**Harbourside Shopping Centre Redevelopment SSD-7874**  
**Amended Concept Proposal and Stage 1 Early Works October 2020 and**  
**Response to submissions**

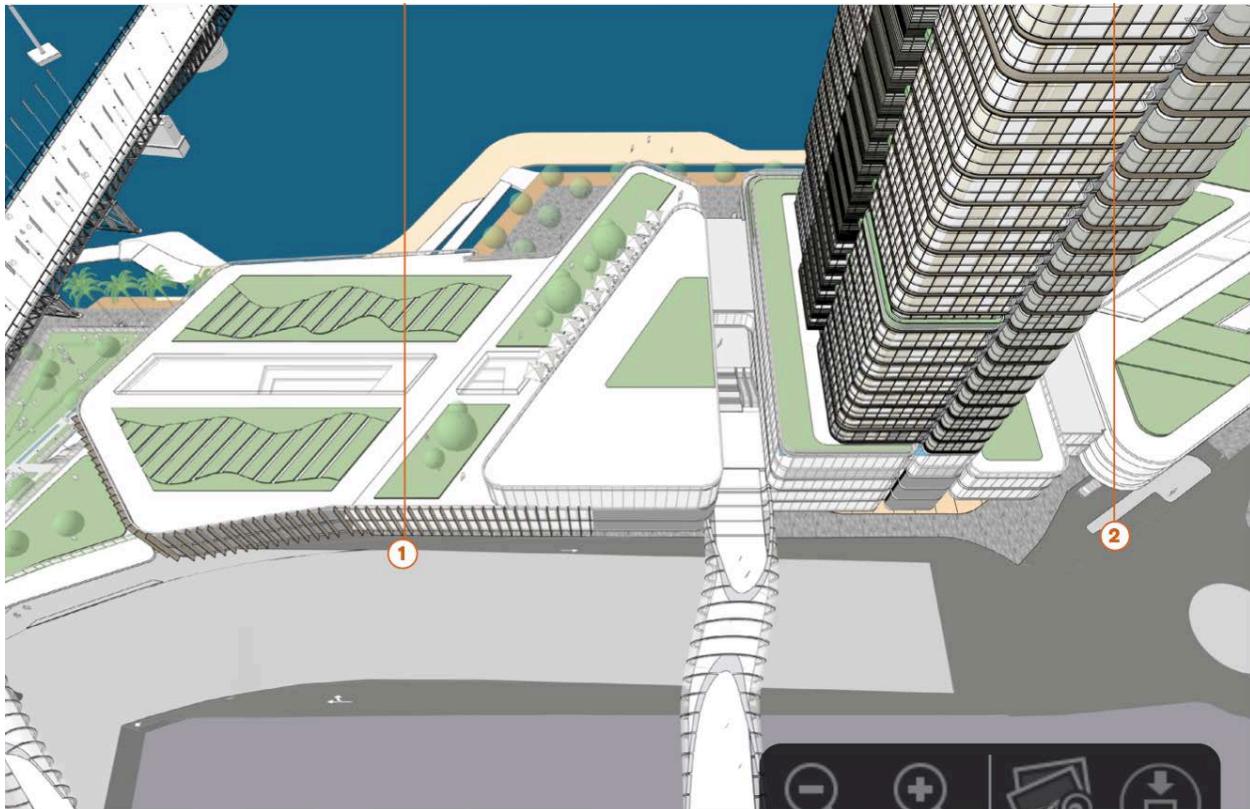
The majority of the **east facing** apartments of 50 Murray Street have highly valued views that enjoy **whole water views of Cockle Bay**. Every aspect (Floor to ceiling glass) of the apartments, in addition to the balcony, have a view of the water. With the previous concept, all east facing apartments at level 8 and below totally lost all Cockle Bay views. The amended concept as shown below still has east facing apartments loosing all Cockle Bay water views.

The proponent claims that by introducing a north east facing 'channel' it provides views north of Pyrmont Bridge and thus claims it has '*significant improved view sharing of 50 Murray Street*'. This is an **unacceptable claim**. It has been pointed out that east faced of 50 Murray Street is a curved. Providing a north east channel at the north end of the proposal has no impact on sharing the water views of Cockle Bay.

*Views from curved 50 Murray Street are inconsistent with the provision of a channel view platform to the north east claiming to have 'significantly improved view sharing of 50 Murray Street'*

### ***Relationship with Pyrmont Bridge***

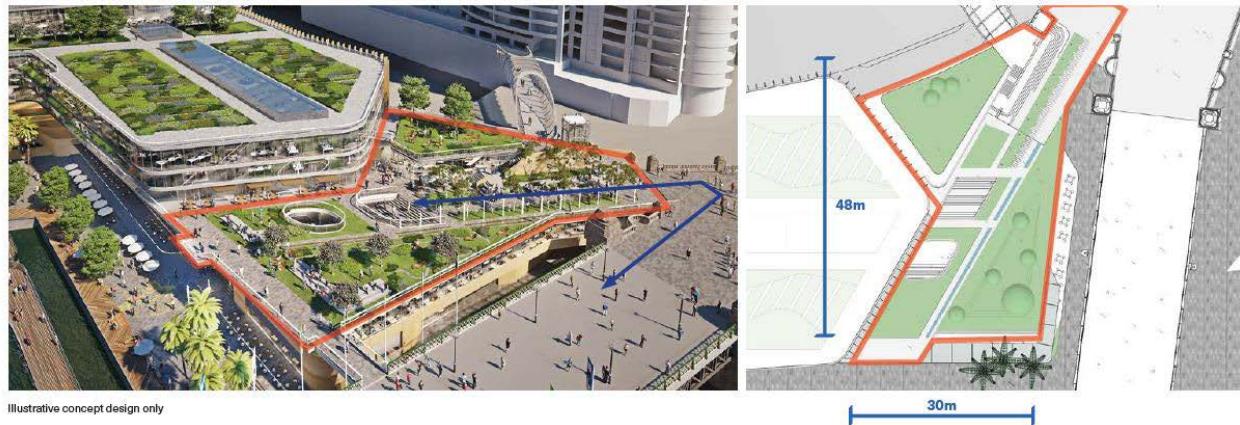
The podium setback to Pyrmont Bridge is only some 25 meters where the RL rises from 13.75 to RL 25 which still significantly overpowers the State listed Pyrmont Bridge. The Cockle Bay side of the Pyrmont Bridge has an RL of 12 for 65 meters.

***Options for Concept change to provide the proponent with the same development potential and reduce the impact on the loss of water view of 50 Murray Street and the impact on the State listed Pyrmont Bridge.***

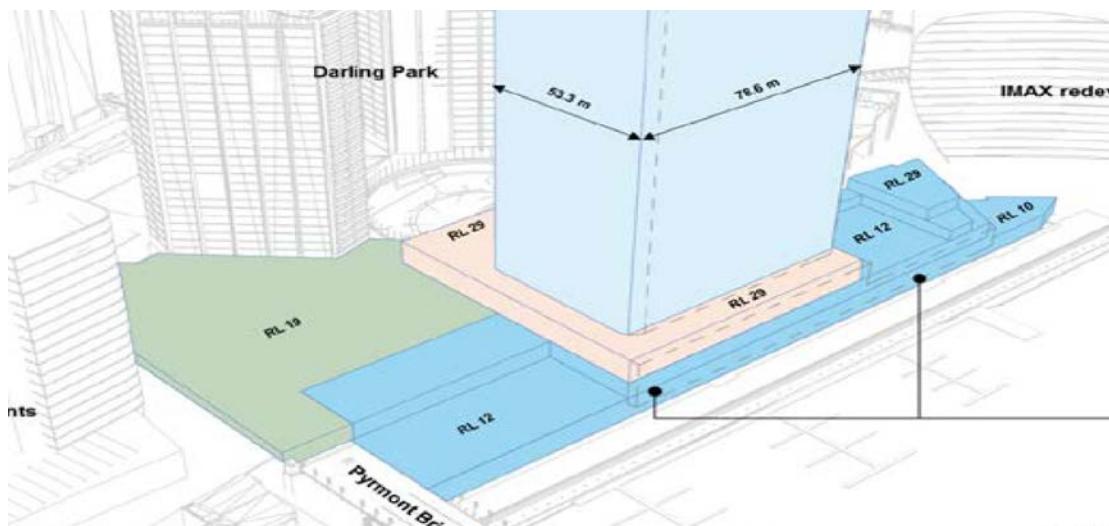
The Darling Harbour Development Plan No.1 is the environmental planning instrument which provides land use controls for land within the Darling Harbour precinct which includes the Harbourside Shopping Centre. The development of the Daring Harbour should all have a similar

strategy to ensure good urban design; consistency in building envelopes and setbacks in regard to the heritage Pyrmont Bridge and the water; as well as meeting the needs of all stakeholders.

The proponent in its current documentation stated that 'establishing a similar strategy as the eastern edge of the Cockle Bay development' supported its tower height. Therefore consideration should be given to the strategy approved by the Department for Cockle Bay development.

The Cockle Bay Wharf State Significant Development (SDD7684) was approved earlier this year. The Department together with the advice from its independent expert design advisor, have gave considerable attention to the issue of the Cockle Bay Wharf development on the visual impact on Pyrmont Bridge and Darling Harbour more broadly. The north podium (closest to Pyrmont Bridge) has an approved RL of 12 at the harbour's edge and RL of 19 over the road providing a on level park some 95m wide. This two level podium extends for 95m away from Pyrmont Bridge before increasing to RL 29 which is only 7.9m before the tower commences.

In contrast, the Harbourside Shopping Centre Redevelopment proposal is for a two level park RL's of 13.75 and RL 17.6 extending away from the Pyrmont Bridge by only some 30m before rising to 25, proposing and RL of for the northern portion of the podium rising to RL 26.5 and then RL31.

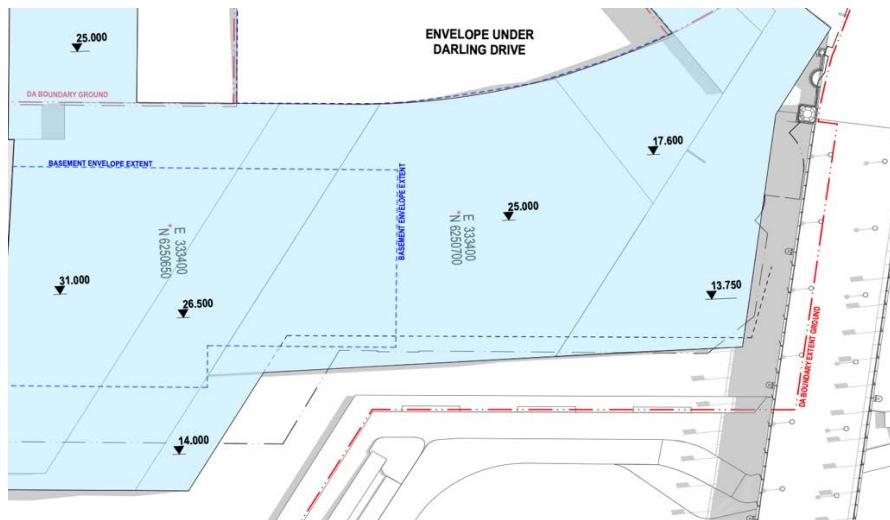
*RL's of Cockle Bay Wharf Approved Development*

*RL's of Harbourside Concept Proposal*

The impact of approving the envelop for the Harbouside Shopping Centre Redevelopment will produce two inconsistent character of addressing the Cockle Bay basin as well as an inconsistent start and end of the Pyrmont Bridge.

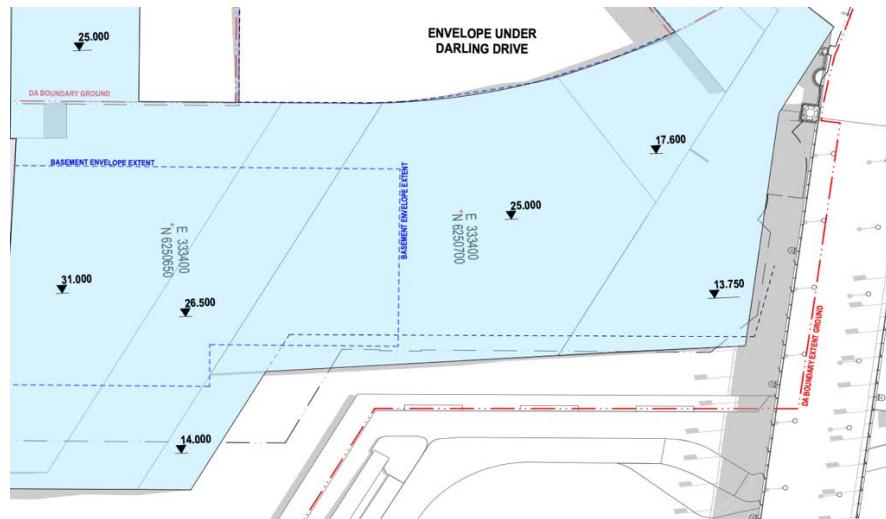
The current use is for 20,000 square meters of GFA of retail. The current proposal is for 87,000 square meters of GFA of which 42,000 sqm is for residential and 45,000 non-residential and of this 8,500 sqm GLA for retail. The **public benefit** for such very significant uplift is stated as **stairs, steps, paving, upgrade of bridge and a 25 meter wide two level public park.**

Further in terms of government's commitment to provide for affordable housing, Mirvac is offering \$5.2m (no affordable housing apartments in our luxury tower just money), which is likely equates to two apartments or some 0.5% of Mirvac's proposed 357 apartments whereas the norm across Council's is 5%.

Mirvac started with 87,000 square meters of GFA in their first concept and although the majority of objections have been focused in bulk and scale, Mirvac has maintained 87,000 square meters GFA in their two Response to Submissions thus far. No doubt their focus to maximise **Mirvac benefit** must have been a challenge in balancing the needs of all stakeholders and providing a balanced public benefit.
